TYPE III –SITE PLAN AND DESIGN REVIEW AND VARIANCE STAFF REPORT AND RECOMMENDATION

FILE NUMBER: GLUA-19-00006/SP-19-00025/VAR-19-00001: Site Plan and Design Review and

REQUEST: The applicant has proposed an approximately 6,500 SF industrial building with

LOCATION: 13896 Fir Street, Oregon City, OR 97045

Figure 3: Proposed Site Plan

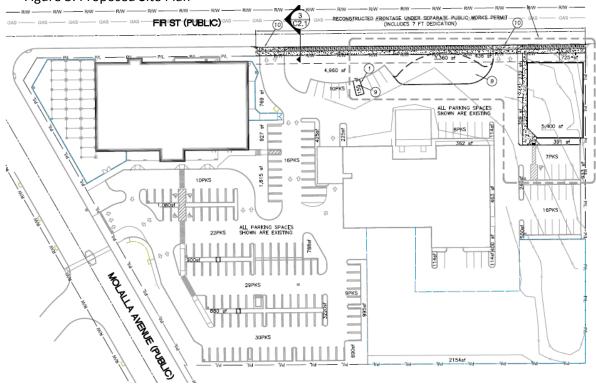
However, the proposed pedestrian circulation system does not connect the main entrance of the proposed building to the warehouse building to the west which includes several tenants. Prior to issuance of a building permit associated with the proposed development, the applicant shall provide a revised pedestrian circulation system which includes a pedestrian connection between the main entrance of the proposed building and the tenant space entrances on the north façade of the warehouse building onsite, such as a striped crosswalk across the drive aisle. Staff has determined that it is possible, likely and reasonable that the applicant can meet this standard through the Conditions of Approval.

Finding: Complies with Condition. The applicant has proposed synthetic stucco as the primary building material, which is similar to Exterior Insulation and Finish System (EIFS). The applicant has not proposed a wood or masonry trim or overhangs to shield the building from extreme weather. The applicant has requested a modification from special materials standards for EIFS or similar troweled finishes. Please refer to the findings in OCMC 17.62.015. **Staff has determined that it is possible, likely and reasonable that the applicant can meet this standard through the Conditions of Approval.**

Finding: Complies with Condition. Though the site is already developed with enough bicycle parking, the existing bicycle parking only serves the Wilco retail store. Prior to issuance of a building permit

- 12. The applicant shall submit a revised pedestrian circulation system which includes a pedestrian connection between the main entrance of the proposed building and the tenant space entrances on the north façade of the warehouse building onsite, such as a striped crosswalk over the drive aisle. The pedestrian connection shall be at least five feet in width and include a visually contrasting surface material. (P)

- 15. The applicant shall provide a revised site plan which includes a minimum of one additional or relocated bicycle parking stall located to serve the proposed cabinet manufacturing building. New or relocated bicycle parking facilities shall be secured in accordance with standards in OCMC 17.52.040.C and located in accordance with bicycle parking location requirements in OCMC 17.52.060.D. (P)
